STATE OF RHODE ISLAND AND PROVIDENCE PLANTATION
DEPARTMENT OF TRANSPORTATION
RHODE ISLAND CONTRACT NO.2012-CT-049
FEDERAL-AID PROJECT NO. FAP Nos: STP-SBPG-002

RI*STARS - Aquidneck Island - Contract 1 (HSIP 406 Funds)

NOTICE TO PROSPECTIVE BIDDERS

ADDENDUM NO. 1 Prospective bidders and all concerned are hereby notified of the following changes in the Plans, Specifications, Proposal and Distribution of Quantities for this contract. These changes shall be incorporated in the Plans, Specifications, Proposal and Distribution of Quantities, and shall become an integral part of the Contract Documents.

**SIGNING & STRIPING
PLAN - 1**

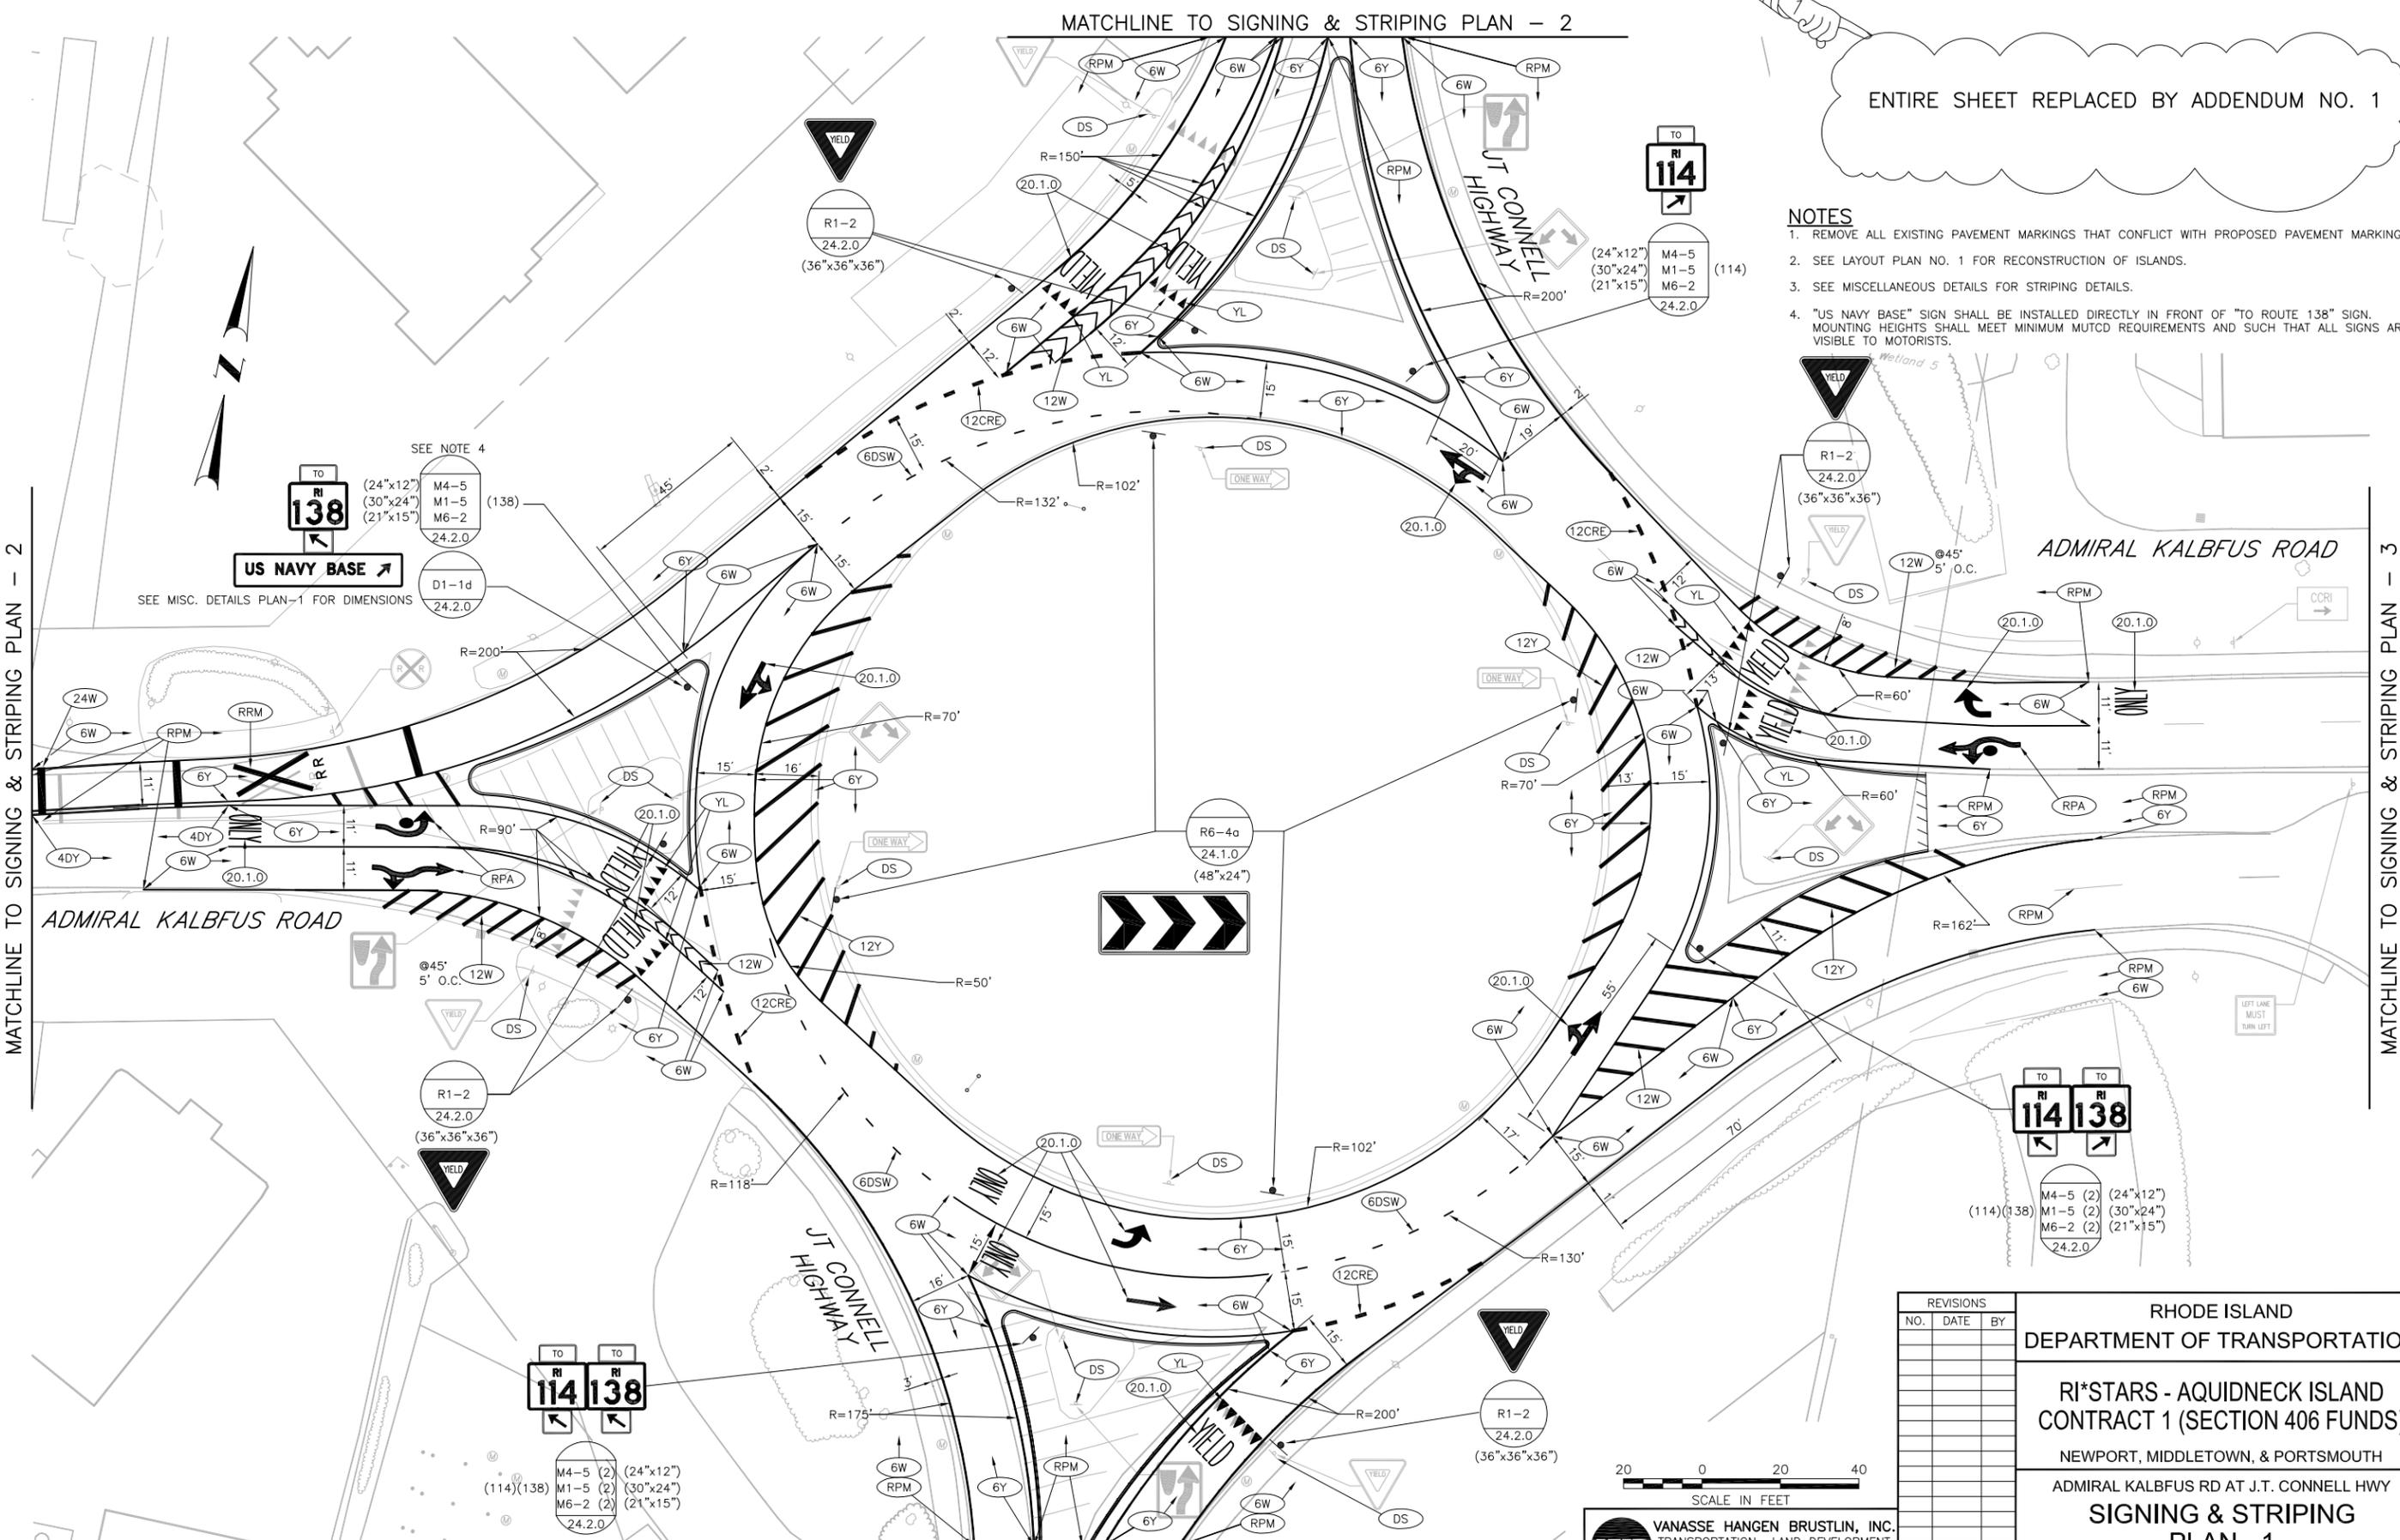
Delete Sheet No. 10 in its entirety and replace it with Sheet No. 10 (R-1) attached to this Addendum No. 1. Dimensions have been added/revised.
